**Re: Crown-Indigenous Relations and Northern Affairs Canada's (CIRNAC's) Review of the 2024 Water Licence Amendment Application by Agnico Eagle Mines Limited for the Meliadine Project Type A Water Licence No: 2AM-MEL1631.**

## **Technical Review Memorandum**

**Subject:** **Crown-Indigenous Relations and Northern Affairs Canada's (CIRNAC's)  
Review of the 2024 Water Licence Amendment Application by Agnico  
Eagle Mines Limited for the Meliadine Project Type A Water Licence No:  
2AMMEL1631.**

**Figure E-5: Projected concentrations of ammonia (NH<sub>3</sub>-N) at SP6 and Waterline during Operations (2024-2031) as compared to the maximum monthly mean effluent concentrations specified in MDMER (Schedule 4, Table 2).**

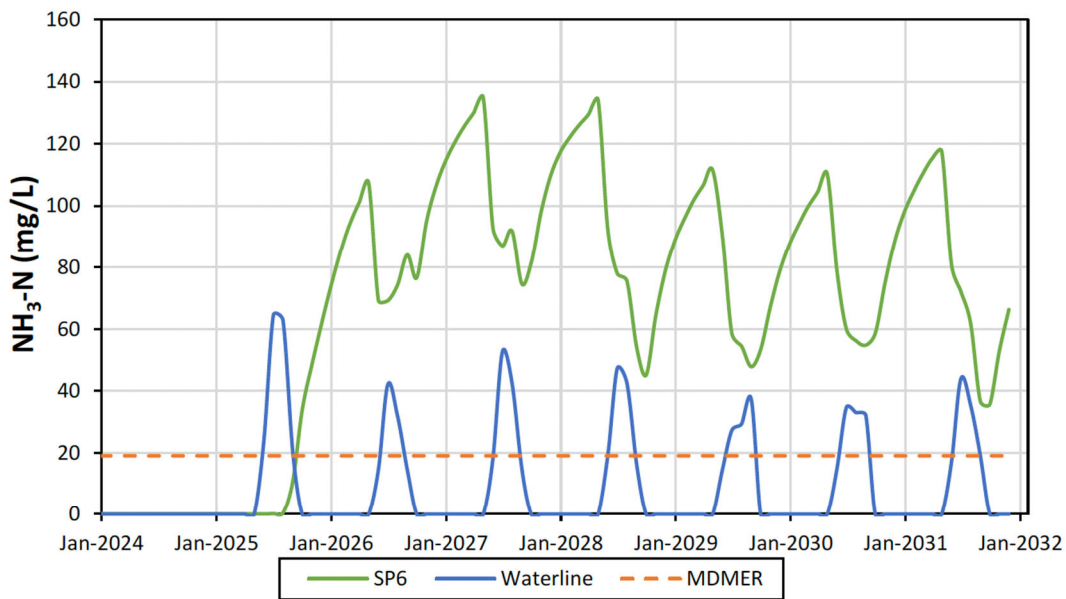
In addition, and as shown in the following figures, multiple parameters are now predicted to exceed applicable water quality criteria during operations, active closure, or the post-closure phases. The amendment application does not present details regarding the steps Agnico Eagle is committed to taking to ensure the exceedances do not occur (e.g., source control) or can be effectively mitigated (e.g., treatment).

As presented in the figures above, multiple parameters approach or exceed the applicable water quality criteria. When considering the predictions and the limited “margin of error”, CIRNAC draws attention to the accuracy of water quality predictions. Although the current amendment application does not state the accuracy of the predictions, prior Agnico Eagle water quality modelling exercises at other mines (e.g., for the Meadowbank and Meliadine Mines) were considered accurate to within one order of magnitude. If the same prediction accuracy is applied to the current application, there is a potential that future contaminant concentrations would significantly exceed the applicable criteria. The amendment application does not address this potential.

- Update all water quality prediction plots to include comparisons to prior FEIS and water licence predictions;
- Specify the anticipated accuracy of the water quality predictions (e.g., within X orders of magnitude);
- Indicate the steps it is taking to prevent and/or mitigate the predicted exceedances and
- Specify how the predicted exceedances and associated uncertainty should influence post-closure monitoring and security requirements.
